Job: QU02697\_RESERVE\_BLDG F1\_REFRESHED\_11252024 - 1246491  
FG02

Original Job: QU02697\_RESERVE\_BLDG F1\_REFRESHED\_11252024

## FG02

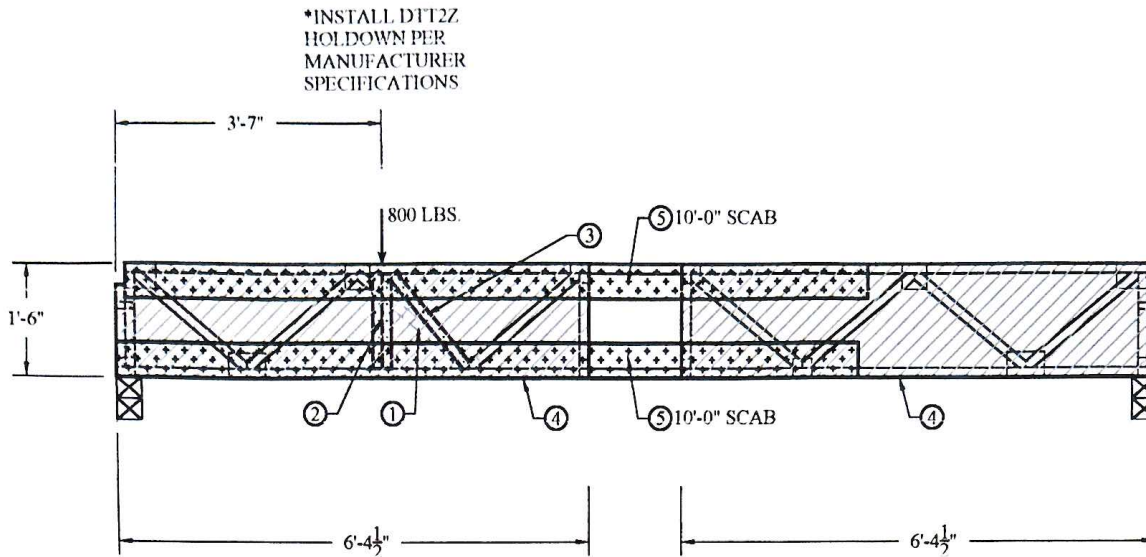
THE TRUSS WILL BE SECURED TO THE LEVEL ABOVE WITH A SIMPSON DTT2Z HOLDOWN. A 800 LBS. POINT LOAD IS APPLIED AT THE HOLDOWN LOCATION, 3'-7" FROM THE LEFT END. THE TRUSS IS COMPLETELY SHEATHED ON ONE SIDE WITH 1/2" OSB.

1. REMOVE PORTION OF TRUSS AS SHOWN. DO NOT DISTURB PLATES AT JOINT 2 (J2). IF PLATES ARE ALTERED AN ENGINEER MUST BE CONSULTED.
2. INSERT (2) NEW 4 x 2 SYP-#1 MEMBERS (ATTACHED TOGETHER WITH (2) ROWS OF (131 x 3") NAILS, OR EQUIVALENT, AT 6" O.C.) IN PLANE AS SHOWN, CUT AND FIT TIGHTLY.

3. INSERT NEW 4 x 2 SYP-#1 MEMBER IN PLANE AS SHOWN. CUT AND FIT TIGHTLY.
4. ATTACH (1) 2-PLY 1/2" OSB TO TRUSS WITH CONSTRUCTION GRADE WATERPROOF GLUE (PL400 OR BETTER) & (1) ROW [2 ROWS INTO DOUBLE MEMBERS] OF 1/4" x 3" FlatLOK SCREWS AT 4" O.C. TO EVERY CONTACT MEMBER; (2-PLY) ONE SIDE ONLY.

5. ATTACH (2) 2 x 6 x 10'-0" SYP-#1 SCABS TO TRUSS WITH CONSTRUCTION GRADE WATERPROOF GLUE (PL400 OR BETTER) AND (1) ROW OF 1/4" x 6" FlatLOK SCREWS AT 4" O.C. TO EVERY CONTACT MEMBER. ONE SIDE ONLY. ATTACH OSB FILLER BETWEEN THE CHORDS/WEBS OF THE TRUSS AND THE SCAB, IF NEEDED. INSTALL OSB PER STEP 4. **INSTALL AFTER THE OSB GUSSETS ARE APPLIED.** TYP. (2) LOCATIONS

1. FULLY SUPPORT TRUSS AND FLOOR/ROOF STRUCTURE BEFORE CUTTING AND REMOVING NECESSARY WEBS AND CHORDS AND ADDING NEW MEMBERS IN-PLANE TO ACHIEVE NEW TRUSS CONFIGURATION.
2. ONLY AFTER REPAIR HAS BEEN INSTALLED PROPERLY SHALL TEMPORARY SUPPORTS BE REMOVED.
